# Access Compliance Report

## Public Rights-of-Way

### (Curb Ramps)

Intersection ID: 26041	Main Street: PROVIDENCE COLONY DR	Cross Street: RAINTREE LN	Location: SE
ADA ID: 927A7CE01C8E	Ramp Type: Perp	Initial Pass/Fail: Fail	Overall Compliance: No
Severity Score: 35			
Codes/Mitigation Info/Possible Solution		Field Measurements/Component Compliance

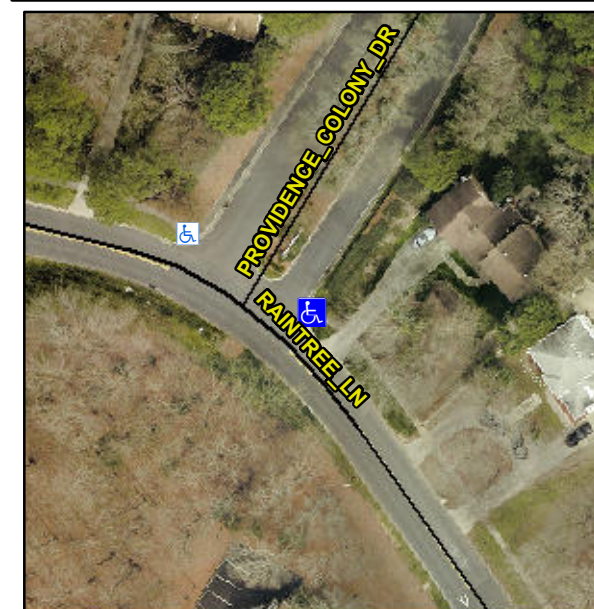
**Not Found, R304.5.1, R304.2.2, R304.5.3**

Compliance	Description	Data	Compliance	Description	Data
N/A	Ramp Length (in)	91.0	No	Ramp Slope (%)	20.0
No	Ramp Width (in)	46.0	No	Ramp XSlope (%)	2.5
N/A	Flare Type LT	N/A	N/A	Flare Type RT	N/A
N/A	Flare Slope LT (%)	N/A	N/A	Flare Slope RT (%)	N/A
N/A	Flare Traversable LT?	N/A	N/A	Flare Traversable RT?	N/A
N/A	Landing Length (in)	N/A	N/A	DWS Provided?	N/A
N/A	Landing Width (in)	N/A	N/A	DWS Contrast?	N/A
N/A	Landing Slope (%)	N/A	N/A	DWS Length (in)	N/A
N/A	Landing X Slope (%)	N/A	N/A	DWS Full Width?	N/A
N/A	Landing Curb? (Y/N)	N/A	N/A	DWS Offset (in)	N/A
N/A	Shared Landing?	N/A			
N/A	Gutter Ponding?	N/A	N/A	Gutter Slope (%)	N/A
N/A	Gutter Lip Ht (in)	N/A	N/A	Gutter X Slope (%)	N/A
N/A	Painted X Walk1?	No	N/A	Painted X Walk2?	N/A
	X Walk 1 Direction	To N		X Walk 2 Direction	N/A
N/A	X Walk 1 Width (in)	N/A	N/A	X Walk 2 Width (in)	N/A
	X Walk 1 Slope (%)	3.9		X Walk 2 Slope (%)	N/A
	X Walk 1 X Slope (%)	4.5		X Walk 2 X Slope (%)	N/A

**Remove & Replace Entire Ramp.**
